DESCRIPTIVE REPORT

Registry No. **H-11130**

General Locality **Sitka Sound**

Sublocality **Vicinity of Vitskari Rocks**

Figure 3. Junction area of surveys H11130 and H11119.

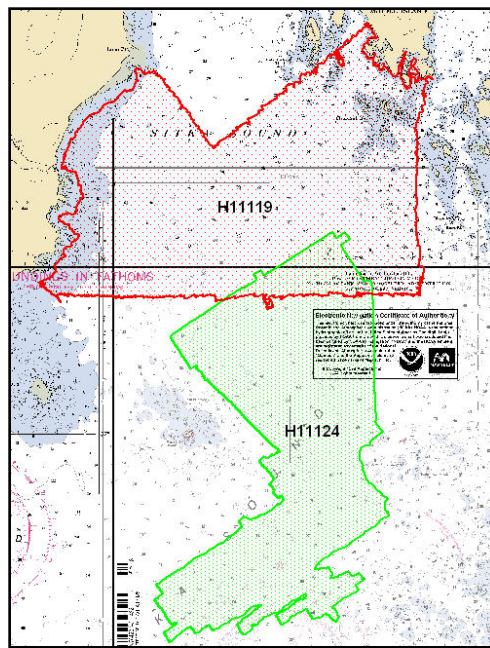
Survey H11119 (OPR-O112-RA-04) was conducted by the NOAA ship RAINIER during the same field season and is not yet available for review. A junction comparison between the two surveys will be completed in the branch office.⁶

⁶ A survey junction comparison with H11119 (northern boundary of H11130) was conducted during Office Review. The surveys agree to within 1 meter in average water depths of over 100m for the vast majority of the overlapping areas. The greatest differences were in small areas of high vertical relief, with a maximum of 9.04 meters.

Figure 6. Evidence of Systematic Errors in the depth layer of the Caris BASE Surface.

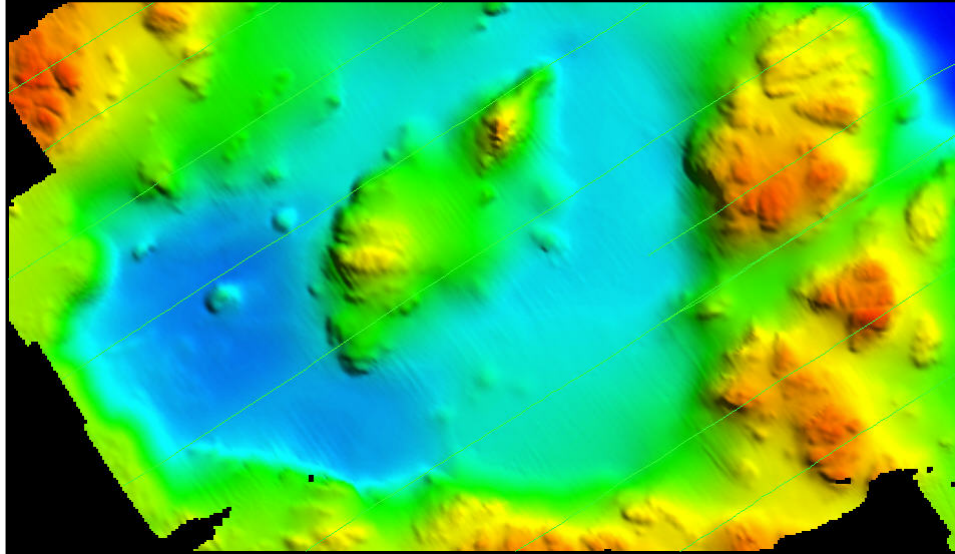
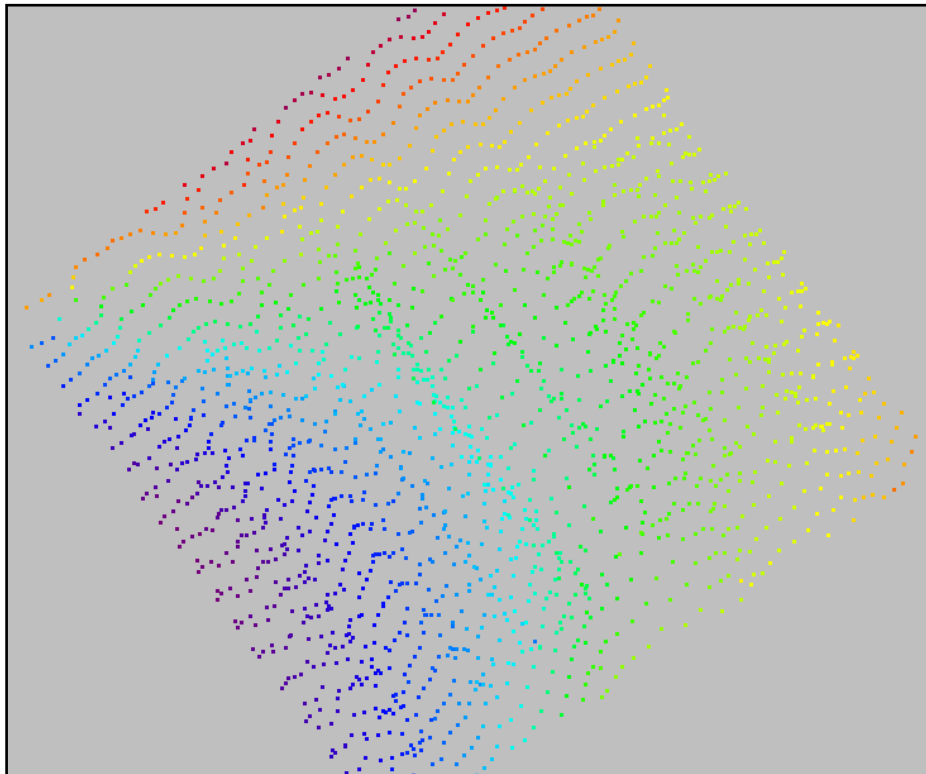
A striping pattern across track was observed in data acquired on JD 302. Sea conditions were rough on this date, with winds recorded at 20-30 knots and waves measured at 8-10 feet. The rough weather conditions may have interfered with the accuracy of the pitch correction, accounting for the striping visible on the depth layer of the BASE surface (Figure 6) and across-track alignment of soundings (Figure 6a).⁷

⁷ All BASE surface soundings met IHO Order 1 tolerances.

Figure 7. High TPE values (blue) in areas of outer beam re-acceptance shown in the uncertainty layer of the Caris HIPS 5.4 BASE Surface.

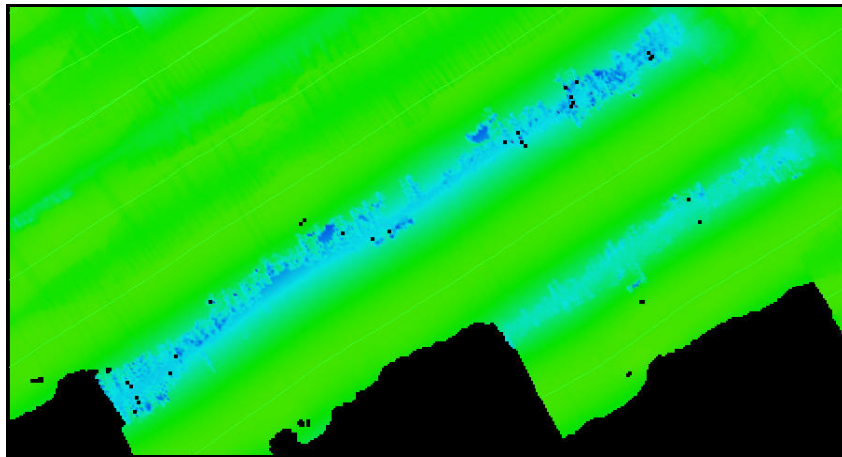
In areas where outer-beam data was re-accepted to cover holidays, TPE values were largest, exceeding 1 meter (Figure 7). The increased uncertainty in this region is due to higher errors associated with beam spreading, sound velocity correction, angular motion, and lower sounding density at outer beams. All BASE surface soundings met IHO Order 1 tolerances.¹⁰

¹⁰ Concur.

Figure 9. Chart Discrepancies for Survey H11130: Shoaler Soundings.

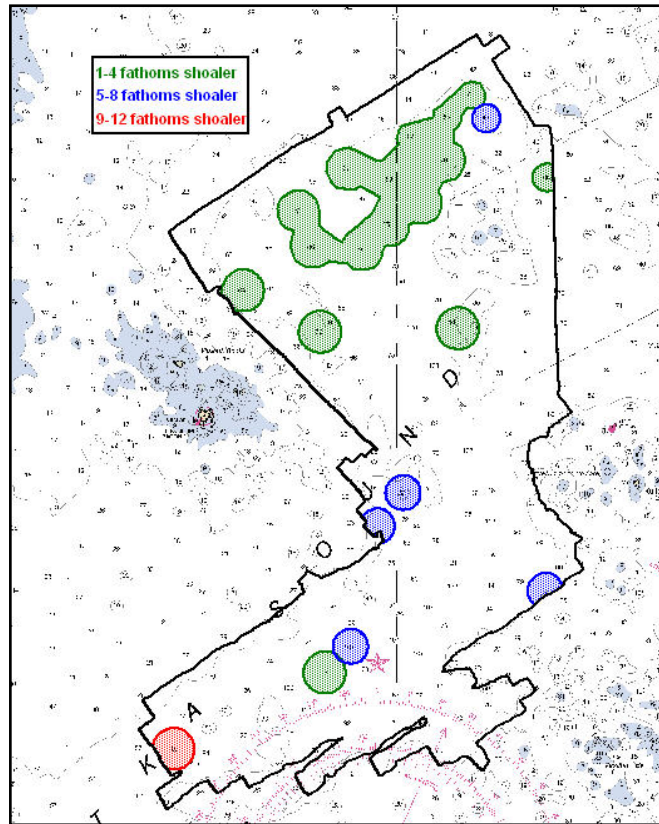
Depths from charts 17326 generally agree with sounding depths from survey H11130, with differences generally less than 0.5 fathoms.¹⁶ In the northern region of the survey, there was a trend of survey soundings being slightly shoaler than the charted soundings, with differences of 1 – 4 fathoms charted in green in Figure 9 below.¹⁷

There were several occurrences where survey soundings over or in the vicinity of charted soundings were greater than 4 fathoms shoaler than charted depths (Figure 9). Positions of these instances are listed in Table 1 below, along with the difference between survey and charted depths.¹⁸

¹⁶ Concur with clarification. Upon PHB review, charted soundings generally agree within 1 fathom. See endnotes 16-23 for a description of more notable discrepancies.

¹⁷ Do not concur. Using the Combined Surface during office review, no trend, either shoaler or deeper, was observed. In general, differences of three fathoms shoaler to 5 fathoms deeper than charted were found in the northern region of the survey.

¹⁸ The largest differences, greater than 5 fathoms, occur in water depths greater than 100 fathoms.
